Attorney Docket No.: 46440-0009017

Presented for filing is a new continuation patent application for prioritized examination of:

Title: BI-DIRECTIONAL FIXATING TRANSVERTEBRAL BODY SCREWS AND POSTERIOR CERVICAL AND LUMBAR INTERARTICULATING JOINT CALIBRATED STAPLING DEVICES FOR SPINAL FUSION

Fig. 2C

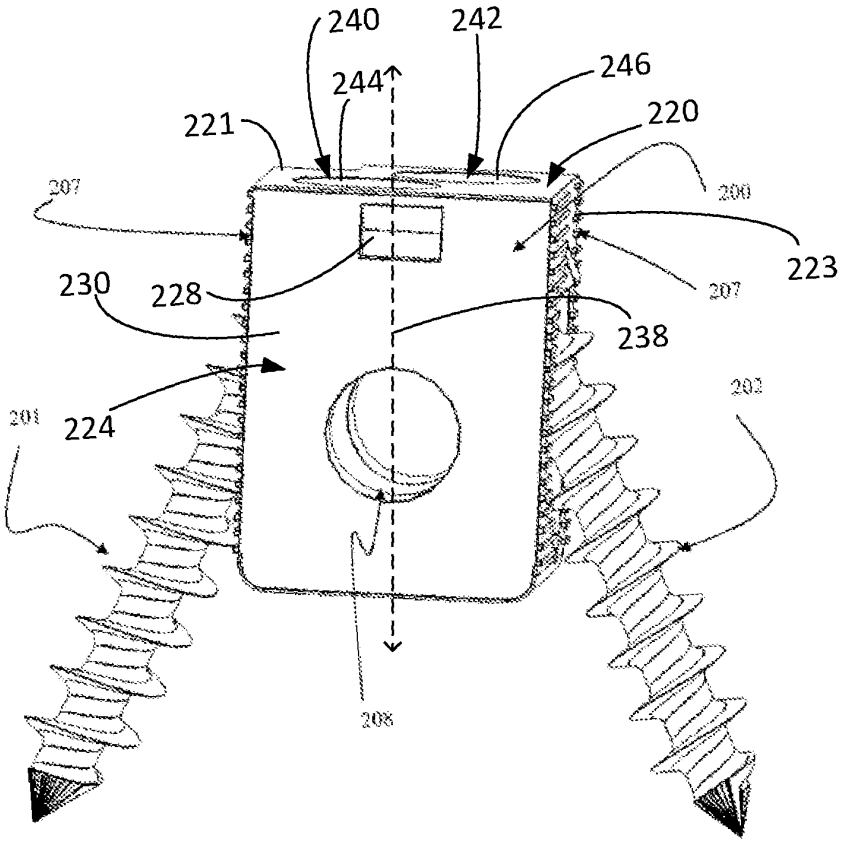
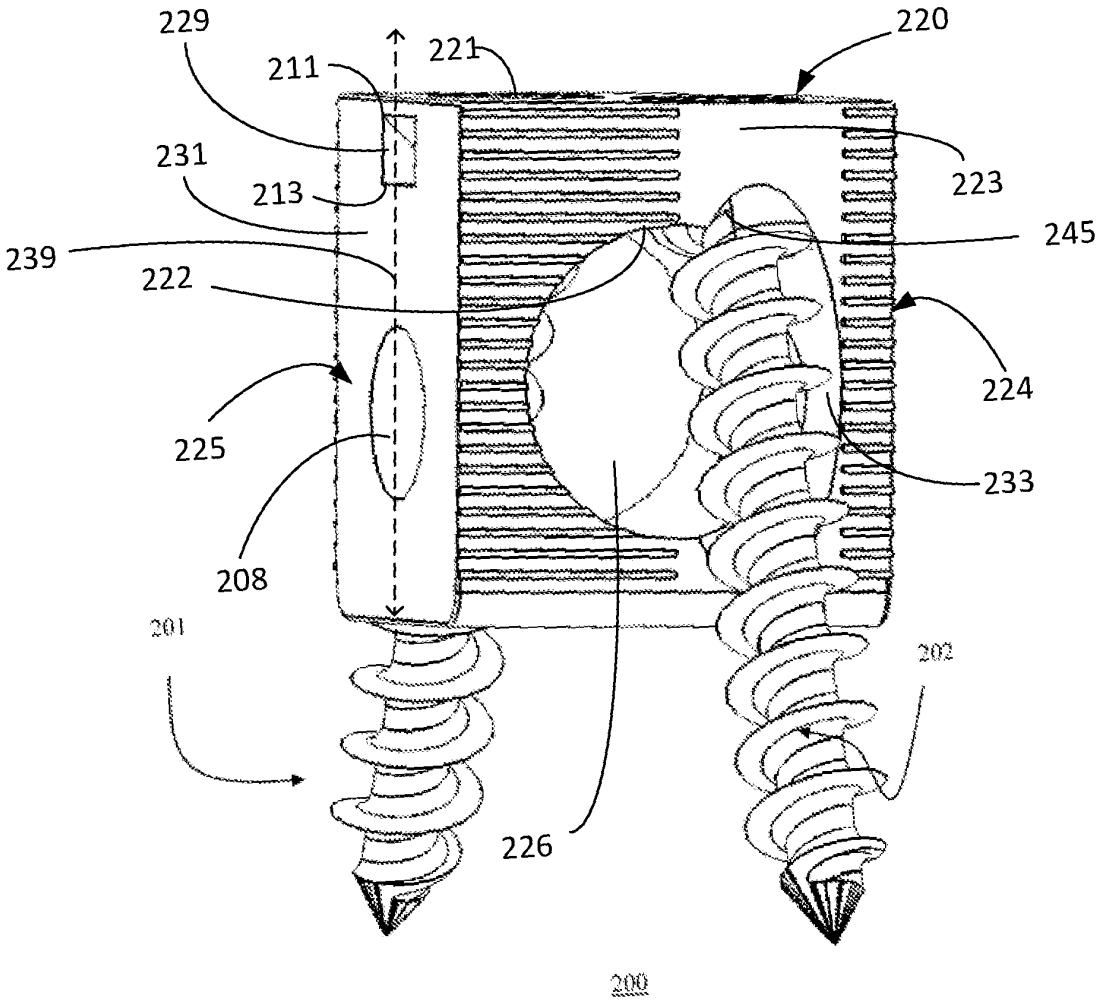
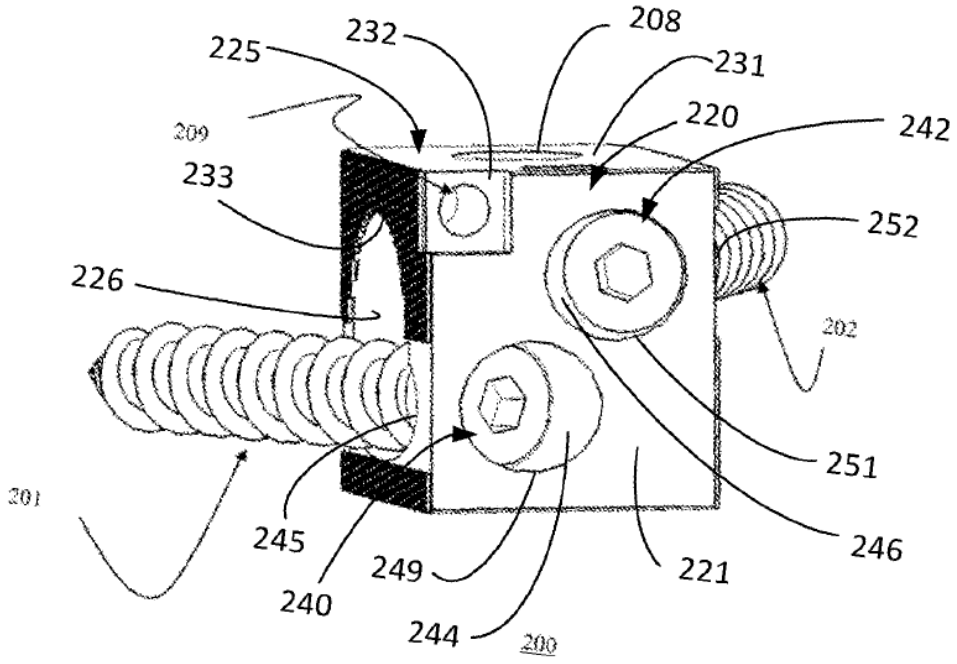
Additionally, Figs. 2A and 2B both illustrate the same side of the implant and therefore should both be given the same name, i.e., the first sidewall (element 224). The examiner understands that the implant has two separate sidewalls but it is noted that only a single sidewall is visible from the Drawings.

Additionally, Figs. 2A and 2B both illustrate the same side of the implant and therefore should both be given the same name, i.e., the first sidewall. The examiner understands that the implant has two separate sidewalls but it is noted that only a single sidewall is visible from the Drawings and therefore the inclusion of the reference numerals and description included in the amended specification should be corrected.

The attached replacement sheets of drawings (3) includes changes to Figs. 2A-2C and replace the original sheets including Figs. 2A-2C.

In Figures 2A-2C, reference numerals and lead lines are added to correspond to the reference numerals associated with the structures recited in the claims in newly amended paragraph [0064.1].

The drawings were objected to as failing to show each and every feature of the invention specified in the claims. Applicant has amended Figs. 2A, 2B, and 2C to include reference numerals and lead lines corresponding to the structures recited in the amended claims, which is further described in amended paragraph [0064.1]. The replacement sheets (3) including Figs. 2A-2C are submitted herewith. No new matter is added by the amendment to the drawings.

Fig. 3

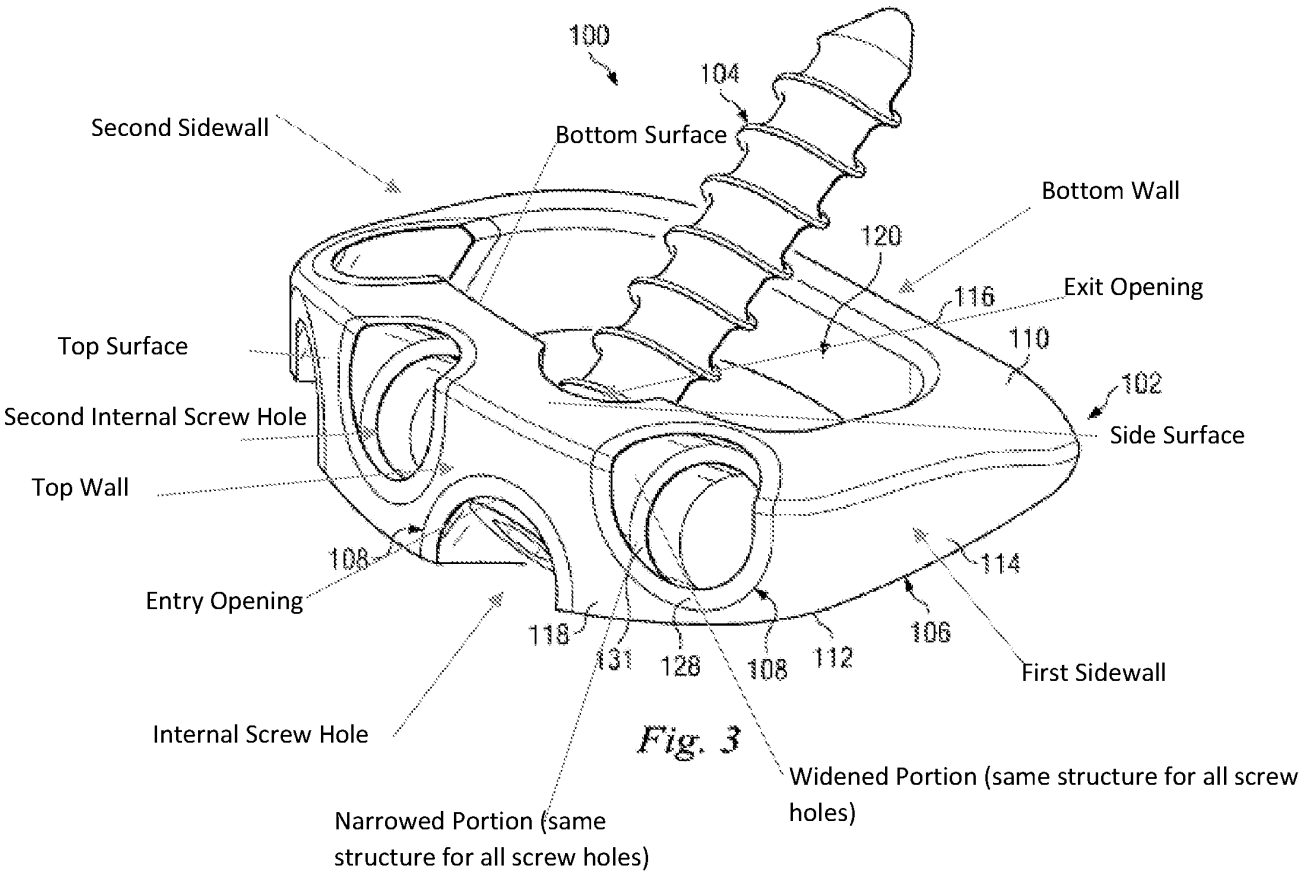
Concerning claim 21, Waugh et al. disclose an intervertebral implant comprising: a top wall (see Fig. 3 below) including a top surface (see Fig. 3 below) and a bottom surface (see Fig. 3 below) opposite the top surface; a bottom wall (see Fig. 3 below) opposite the top wall; a first sidewall (see Fig. 3 below); a second sidewall (see Fig. 3 below) opposite the first sidewall, wherein the top wall, bottom wall, first sidewall and second sidewall comprise a unitary structure and define an open space (see Fig. 3 below) capable of receiving bone filling for biological bone fusion; and an internal screw hole (see Fig. 3 below) defined by the intervertebral implant and extending from an entry opening (see Fig. 3 below) formed in the top wall to an exit opening (see Fig. 3 below) formed at least partially in the bottom surface of the top wall and at least partially in a side surface (see Fig. 3 below) of the top wall, the internal screw hole having a widened portion (see Fig. 3 below) and a narrowed portion (see Fig. 3 below), the widened

Concerning claim 22, wherein the widened portion extends into the top wall so as to recess all portions of the screw head below the top surface of the top wall (see Fig. 3 above).

Concerning claim 30, wherein the internal screw hole is a first internal screw hole, and the intervertebral implant further comprises: at least a second internal screw hole (see Fig. 3 above) extending from a second entry opening formed in the top wall to a second exit opening, the second screw hole comprising a second widened portion extending into the top wall from the second entry opening, the second internal screw hole oriented in a different direction than the first internal screw hole (see Fig. 3 above).

Concerning claim 33, Waugh et al. disclose an implant system comprising: a top wall (see Fig. 3 above) including a top surface (see Fig. 3 above) and a bottom surface (see Fig. 3 above) opposite the top surface; a bottom wall (see Fig. 3 above) opposite the top wall; a first sidewall (see Fig. 3 above); a second sidewall (see Fig. 3 above) opposite the first sidewall, wherein the top wall, bottom wall, first sidewall and second sidewall comprise a unitary structure and define an open space capable of receiving bone filling for biological bone fusion; and an internal screw hole (see Fig. 3) defined by the intervertebral implant and extending from an entry opening (see Fig. 3) formed in the top wall to an exit opening (see Fig. 3) formed at least partially in the bottom surface of the top wall and at least partially in a side surface of the top wall, the internal screw hole having a widened portion (see Fig. 3) and a narrowed portion (see Fig. 3), the widened portion extending into the top wall from the entry opening and configured to recess a screw head below the top surface of the top wall, the narrowed portion coupled to the widened portion and configured to receive a screw body.

Fig. 12

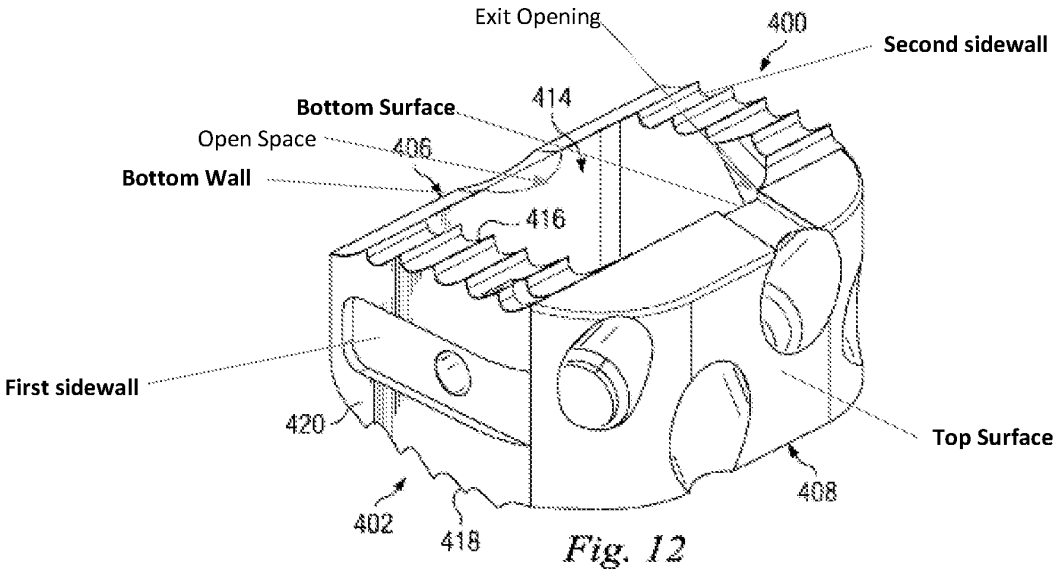
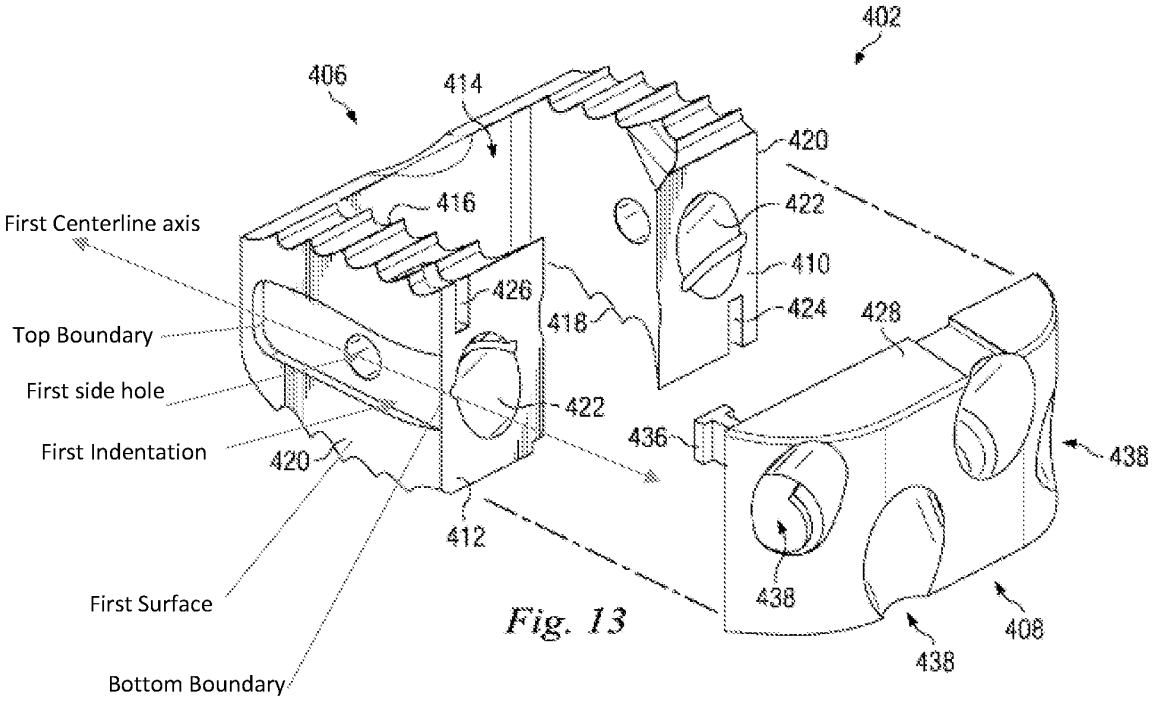
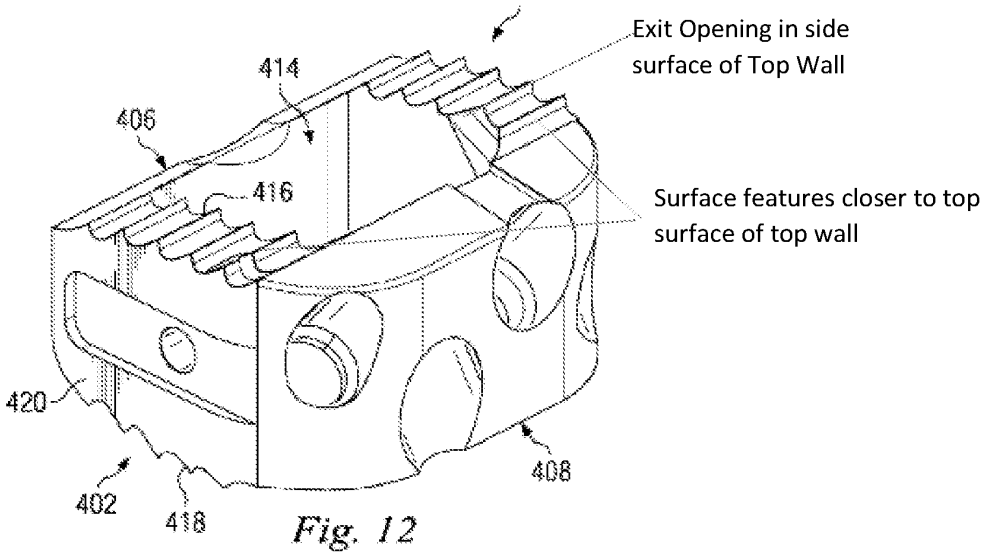
In the embodiment of Fig. 12, Waugh specifically discloses a first indentation (see Fig. 13 below) on a first outer side surface of the first sidewall; a second indentation on a second outer side surface of the second sidewall, wherein the second indentation is positioned opposite of the first stet indentation; a first circular side hole (see Fig. 12 above) extending into the first outer side surface of the first sidewall; a second circular side hole extending into the second outer side surface of the second sidewall, wherein the second circular side hole is positioned opposite of the first circular side hole, wherein the first indentation and the first circular side hole are both positioned along a first centerline axis (see Fig. 12 above) that bisects the first sidewall, and wherein the second indentation and the second circular side hole are both positioned along a second centerline axis that bisects the second sidewall. The indentation provides a gripping region for an inserter instrument and the hole permits bone ingrowth after implantation.

It would have been obvious to one having ordinary skill in the art at the time the invention as made to modify the embodiment illustrated in Fig. 3 to include the instrument gripping region and side holes for bone ingrowth in order to provide insertion ease and better fusion of the implant to adjacent bone.

Fig. 12

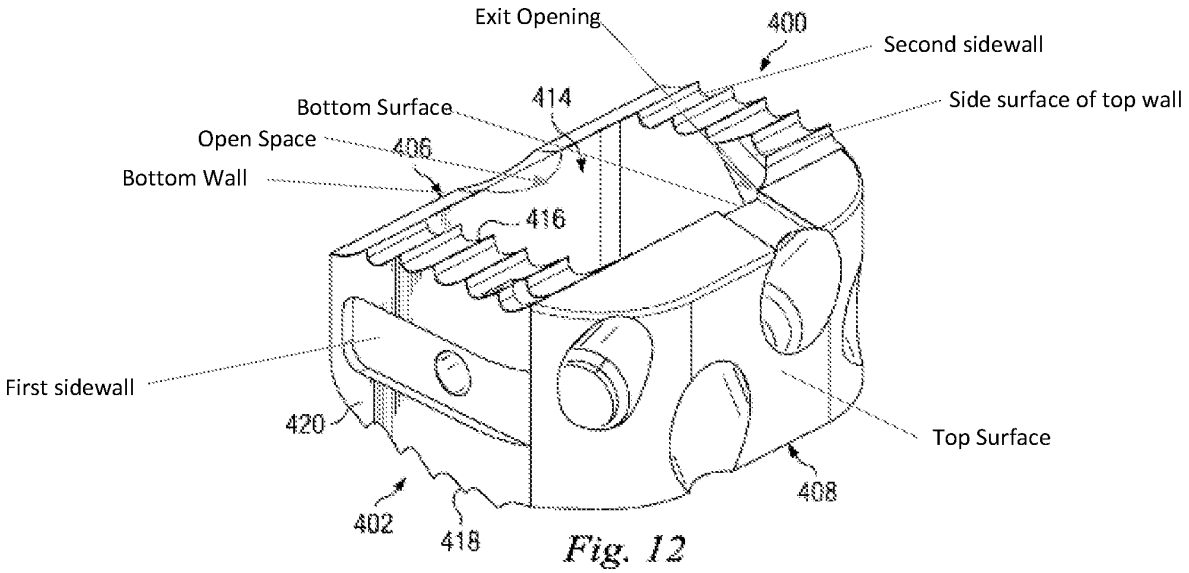
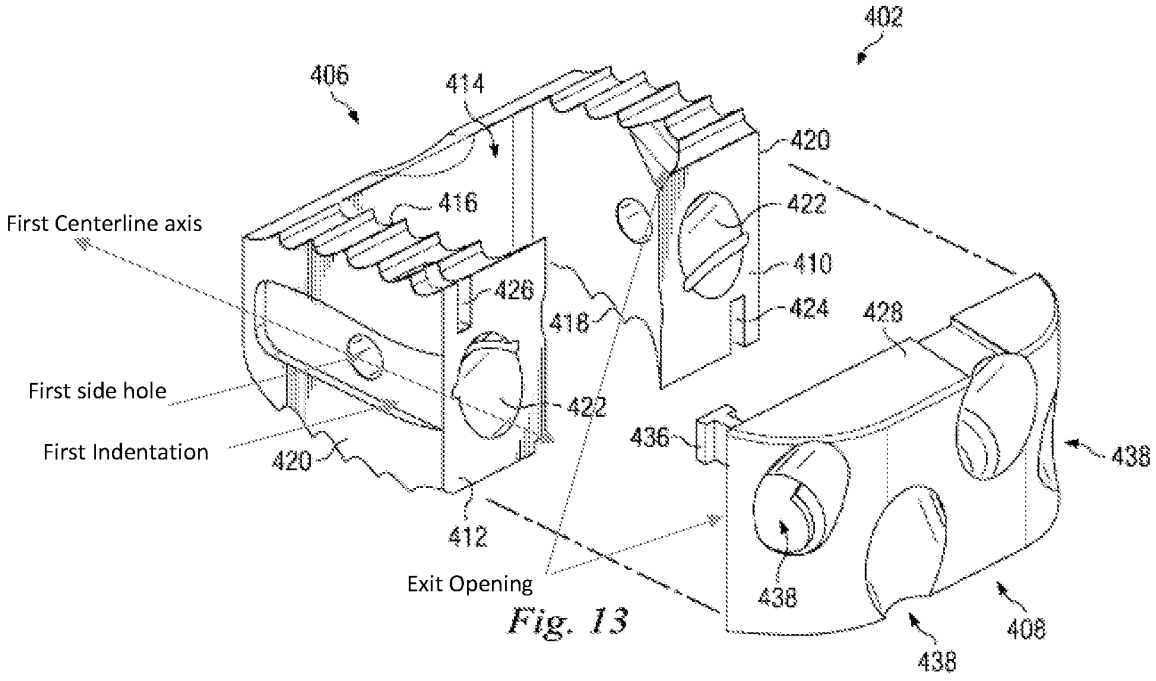
Concerning claim 45-47, Waugh et al. disclose an intervertebral implant system comprising: a top wall (see Fig. 3 above) including a top surface (see Fig. 3 above) and a bottom surface (see Fig. 3 above) opposite the top surface; a bottom wall (see Fig. 3 above) opposite the top wall; a first sidewall (see Fig. 3 above); a second sidewall (see Fig. 3 above) opposite the first sidewall, wherein the top wall, bottom wall, first sidewall and second sidewall comprise a unitary structure and define an open space (see Fig. 3 above) capable of receiving bone filling for biological bone fusion; and an internal screw hole (see Fig. 3 above) extending from an entry opening (see Fig. 3 above) formed in the top wall to an exit opening (see Fig. 3 above) formed at least partially in the bottom surface of the top wall and at least partially in a side surface of the top wall (see Fig. 3 above), the internal screw hole having a widened portion and a narrowed portion, the widened portion extending into the top wall from the entry

Concerning claim 48, wherein the intervertebral implant system does not include a faceplate to retain the screw head in the internal screw guide (see Fig. 12).

Fig. 12

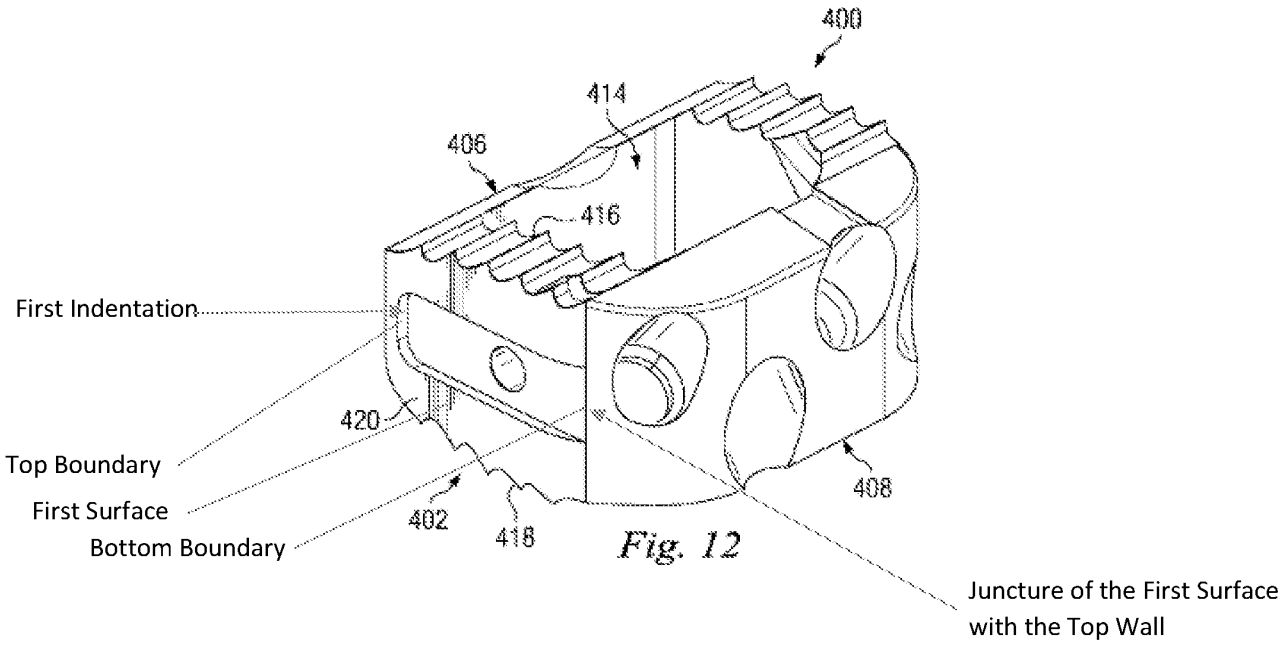
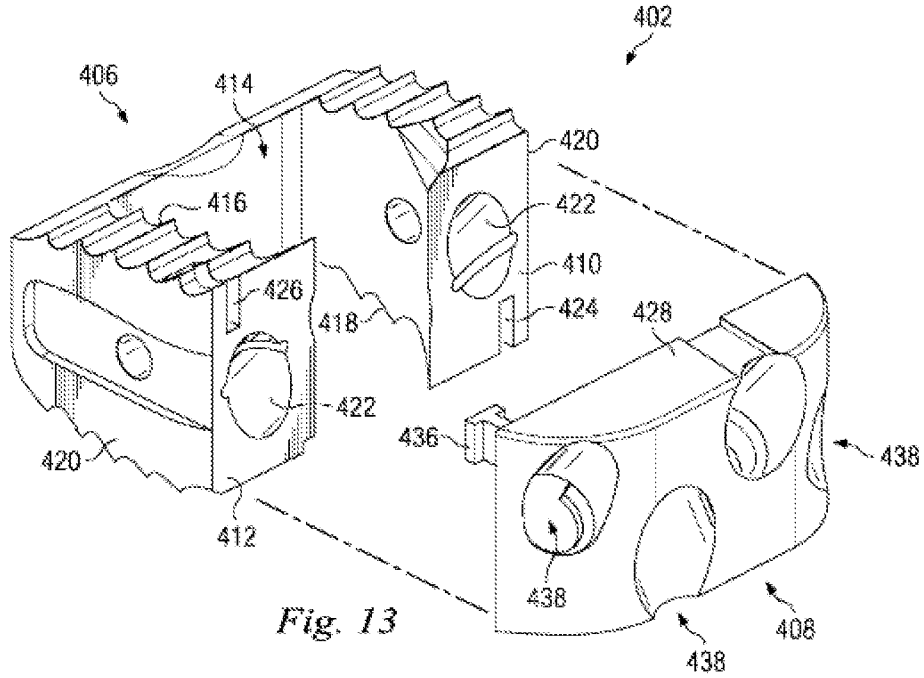
Applicant's arguments filed 03/21/2023 have been fully considered but they are not persuasive. In response to Applicant's argument that "Waugh '000 fails to teach or suggest a unitary structure," it is noted that Fig. 3 illustrates a unitary structure 100.

Regarding Applicant's argument that "the elongated slot of Waugh '000 fails to disclose a first indentation bounded by a top boundary and a bottom boundary, the bottom boundary of the first indentation positioned closer to a juncture of the first surface with the top wall than to a juncture of the first surface with the bottom wall," it is noted that Waugh's slot includes boundaries as claimed. See Fig. 12 below.
